**COUNTRY CLUB DEVELOPMENT**

**CONCEPTUAL GRADING AND DRAINAGE PLAN**

# TEMPORARY DRAINAGE CERTIFICATION

# **EASTERN BUILDING DRAINAGE CERTIFICATION**

# **WESTERN BUILDING DRAINAGE CERTIFICATION**

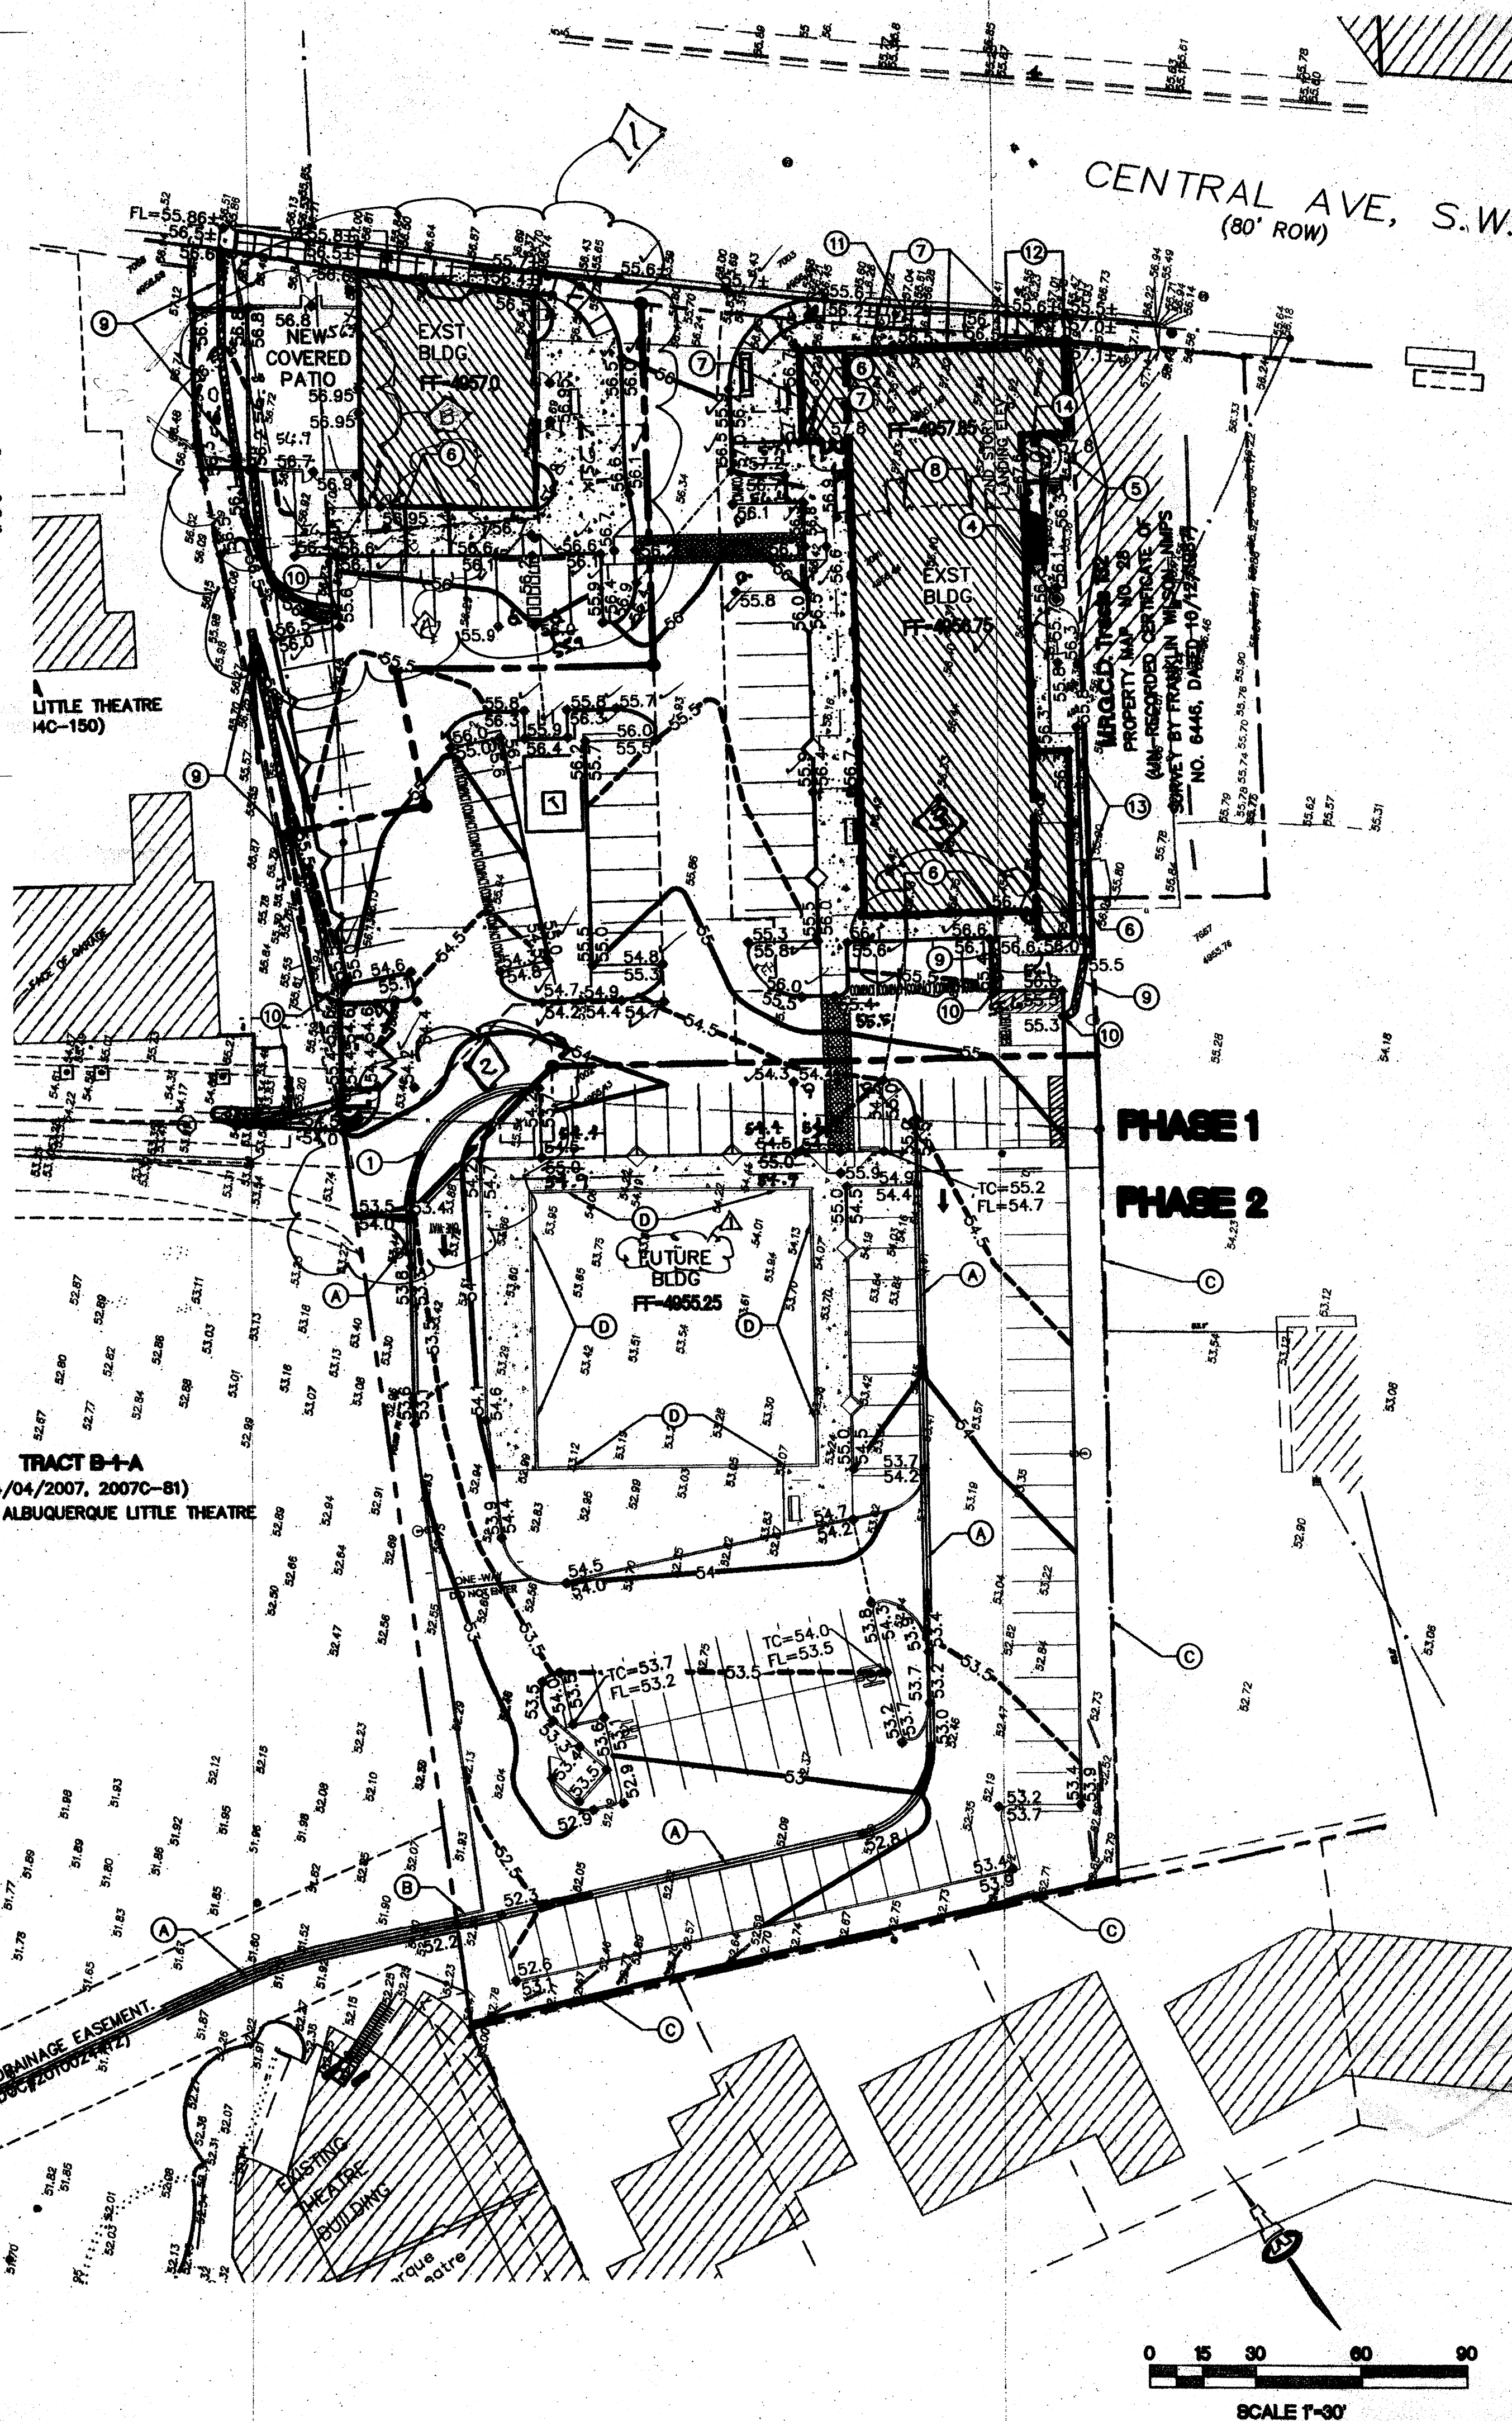
- The roof drains on the south side of the Vinalgrete building were changed to discharge across the sidewalk, rather than through 4" PVC pipes under the sidewalk. This change is acceptable.
- The covered patio has not been covered, and has been expanded west to the property line. The western 1/3 of the courtyard will be a stormwater harvesting area for a garden. Drainage holes were added to the south side of the wall to allow water to overflow from the stormwater harvesting area. This change is acceptable.
